# VERIFICATION REPORT

5<sup>th</sup> Verification of  
**Xiaogushan Hydropower Project in  
People's Republic of China**

CDM Reference No. 0378

Report No. GR11W0003D

**Figure 2: Water flow of Heihe River and generation**

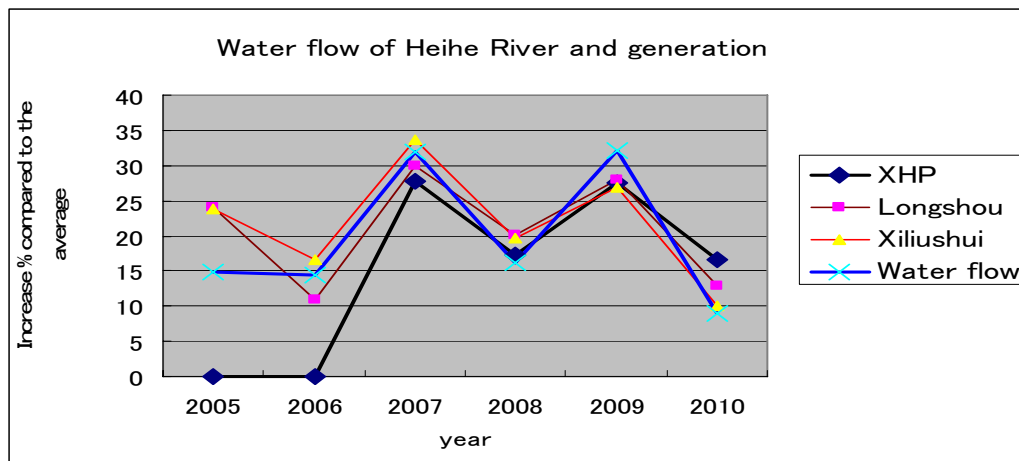
- (1) Is there any case that XHC imported the electricity from the grid?
- (2) Invoice of XHC to PGTC and Evidences of EGaux for the line 1117 & 1118 and EGplant are to be provided.
- (3) The electricity generation increase in 2010 is 16.6% of the PDD against the river water flow rate increase of 8.8%. On the other hand, the electricity generation increase in 2009 is 27.6% against the river water flow rate increase of 32.1% and these data are nearly proportionate.

Further, the power generation data (2005-2010) for the two other hydropower plants (Longshou and Xiliushui), which are located in the downstream of Heihe river shows a very consistent pattern with the generation data of the Xiaogushan power plant and the hydrological statistic of the Yingluo Gorge, which is illustrated in Figure 2 below. (/17/) This proves that the increase in annual electrical supply to the grid and power generation is due to the increased water flow.
